AN ANALYSIS OF ALTERNATIVE DESIGNS FOR ALMUS DAM

CRITICAL DISCUSSION OF THE DAM DESIGN SELECTED BY D.S.İ.

THESIS

MAY 1961

# INFLOW MASS CURVE OF MOST CRITICAL YEARS YESILIRMAK - ALMUS

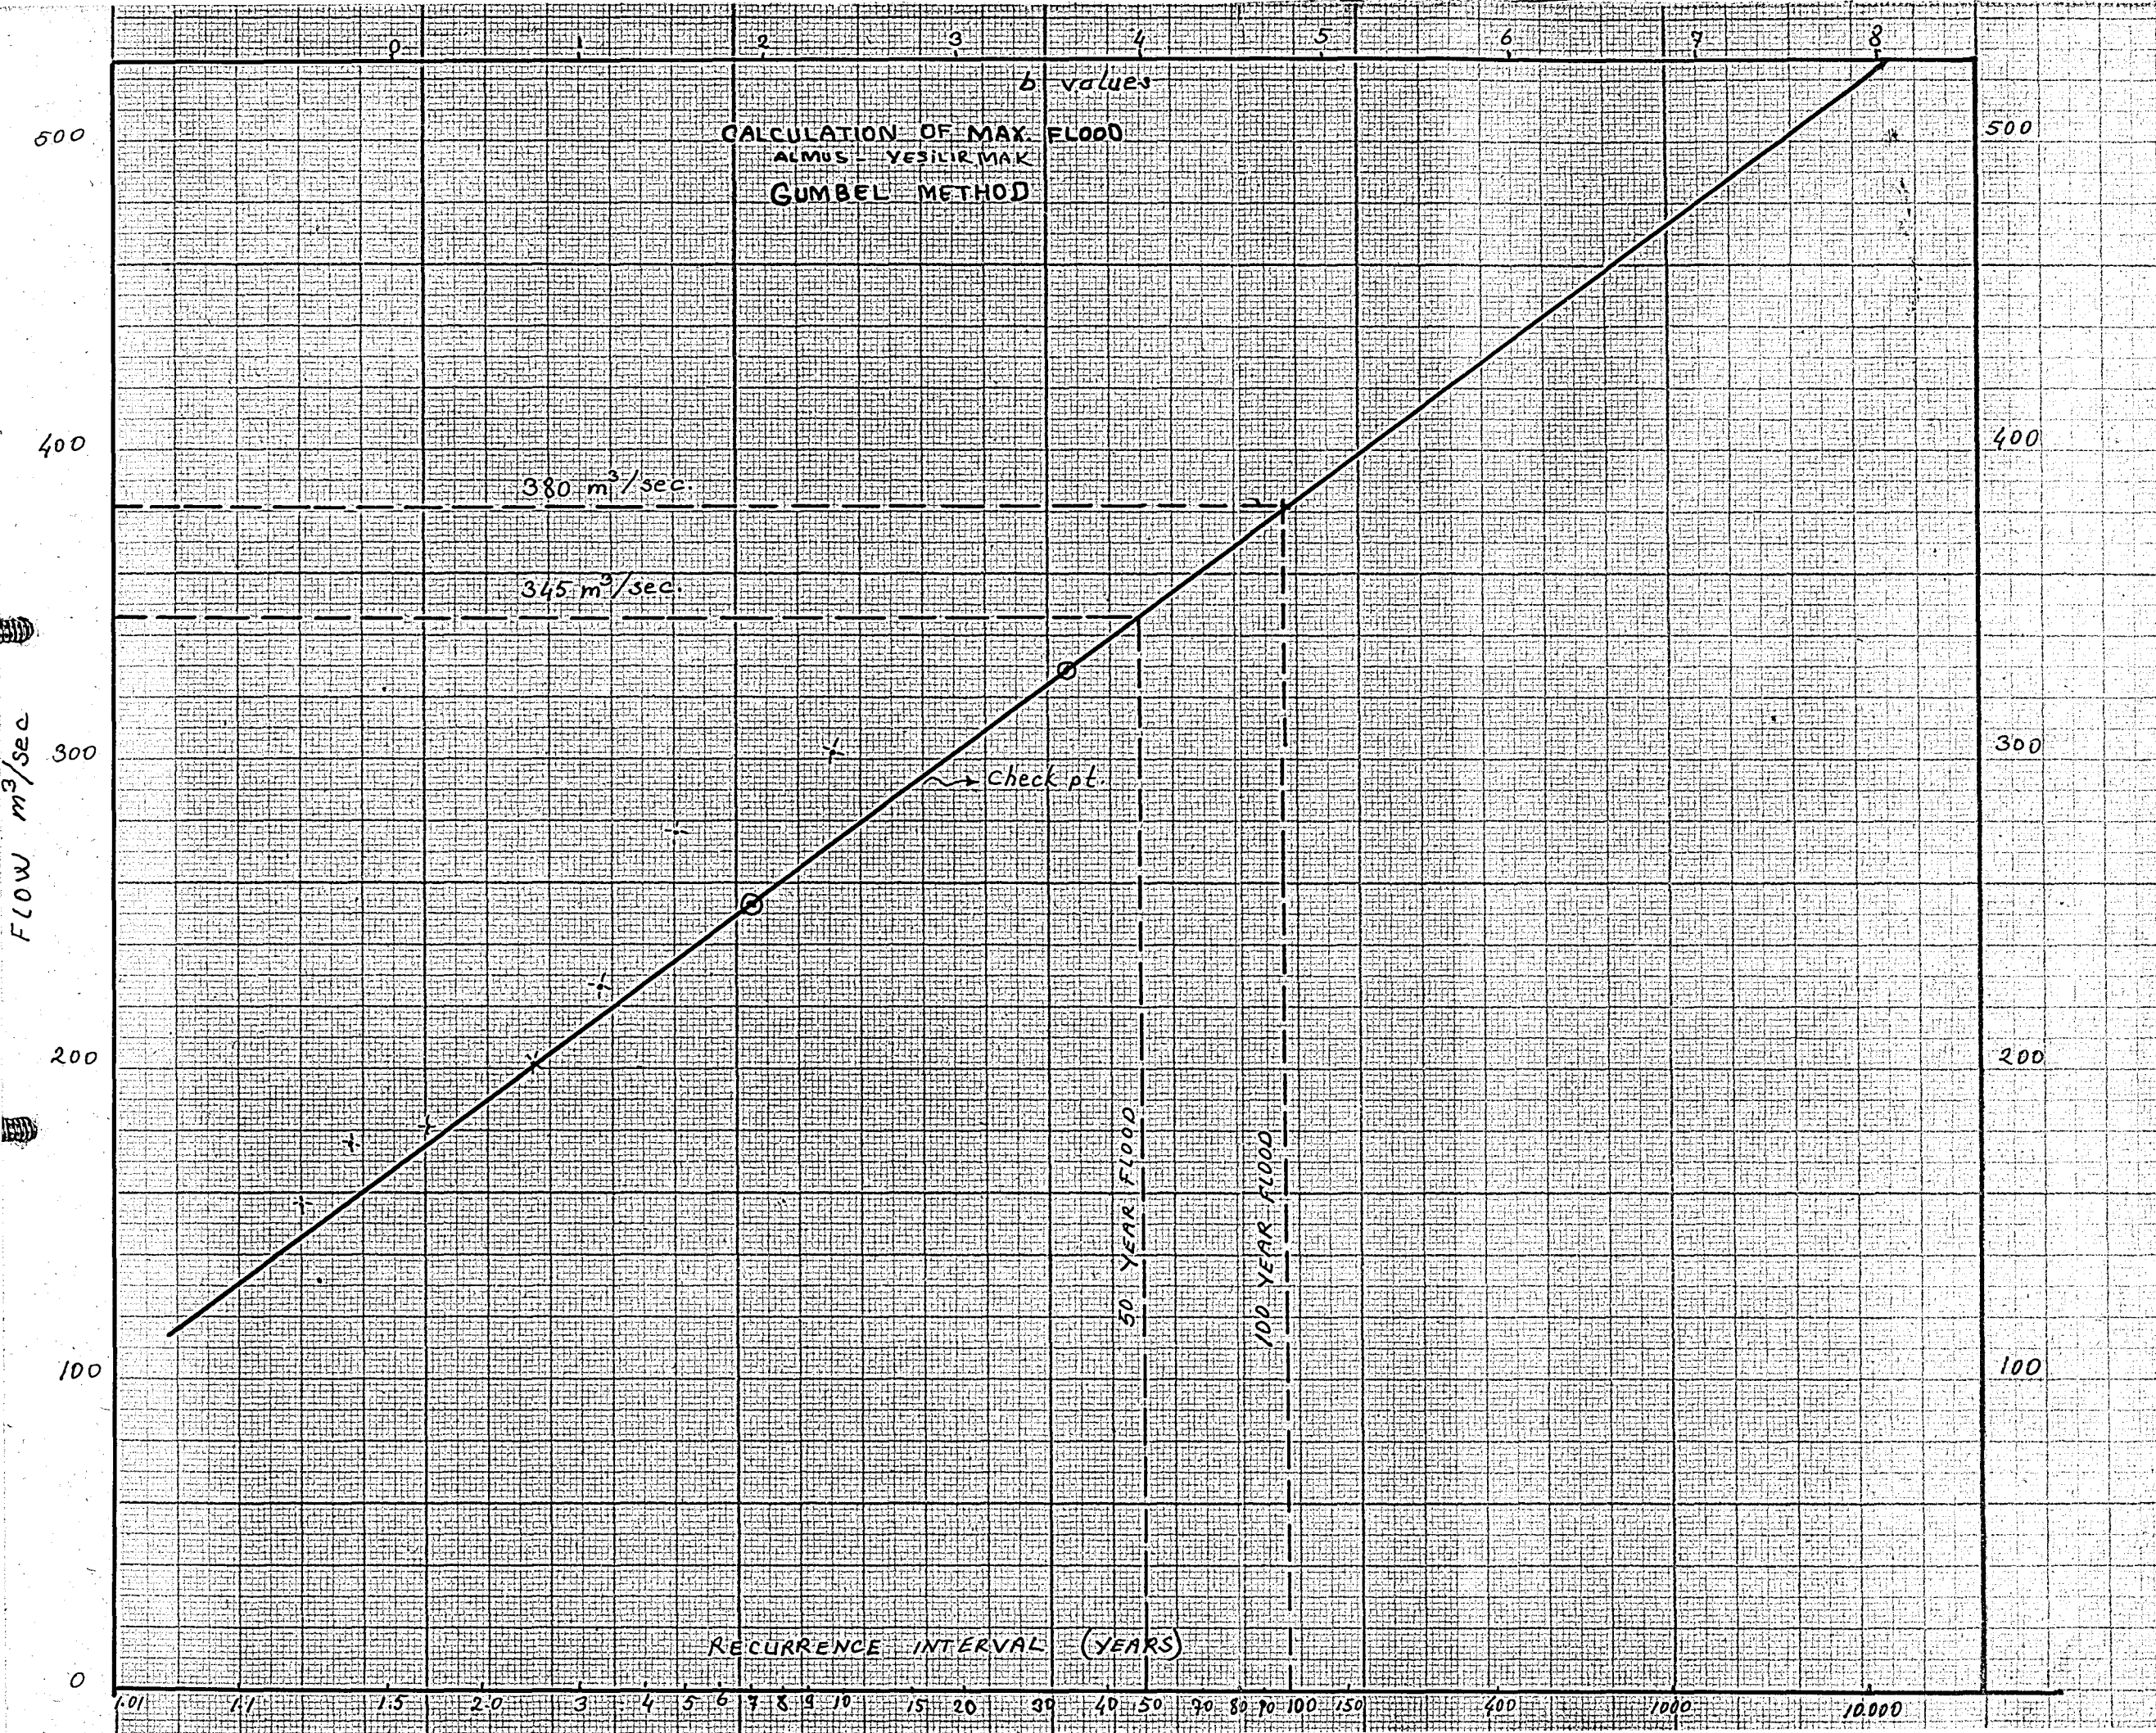
but if regulation desired  
to average streamflow (24-year  
record) of  $758 \times 10^6 m^3$  or  
 $24.3 m^3/s$ , res. capacity  
required is abt  $630 \times 10^6 m^3$   
D.S.I. has chosen  $700 \times 10^6$

*I do not find this figure in the D.S.I. report, and cannot understand*

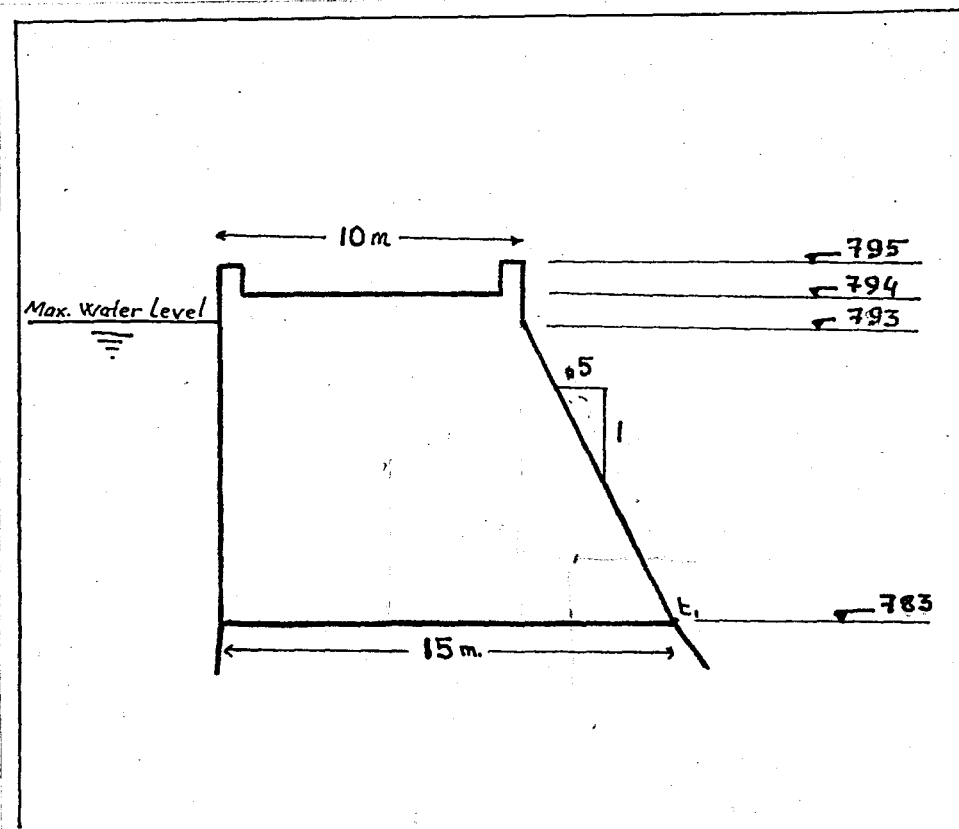
very deep  
excavation  
is that much  
?

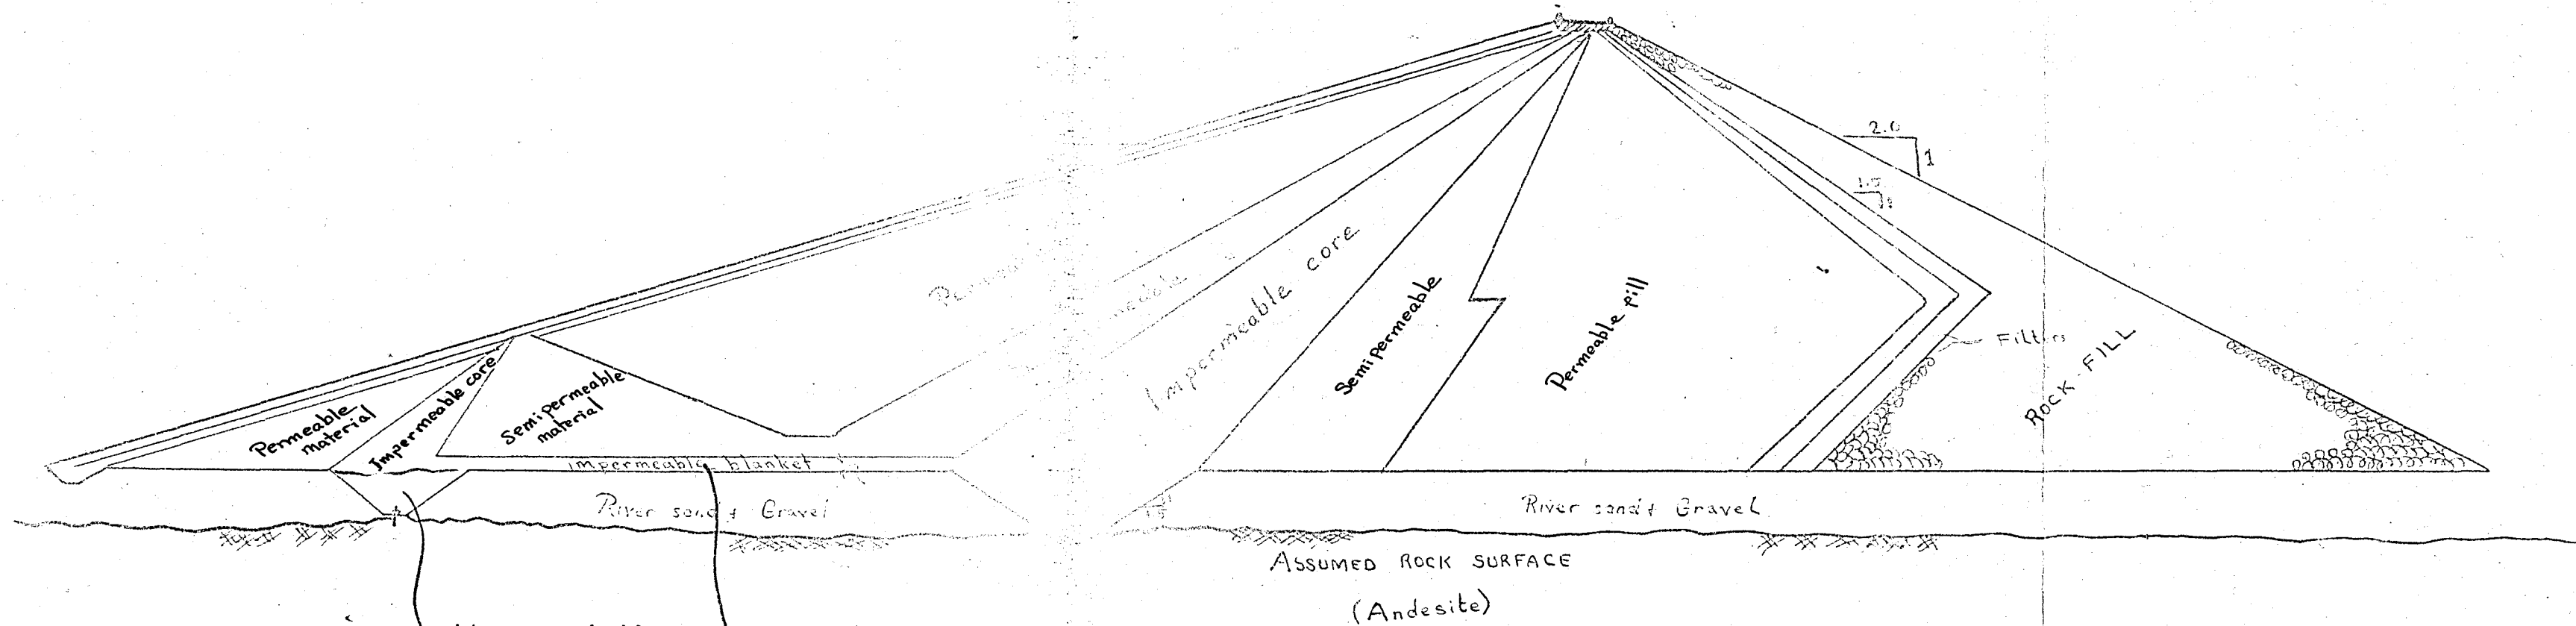
It is also advisable to provide a second smaller cut-off trench under the cofferdam that will reduce the seepage while the main dam is under construction and will be of great help in reducing the seepage later on when the structure is completed. *probably not alone and impossible to build*

in practice probably  
impossible to provide  
(without a cofferdam for  
the cofferdam)

probably also  
impossible to provide  
(the river is flowing!)
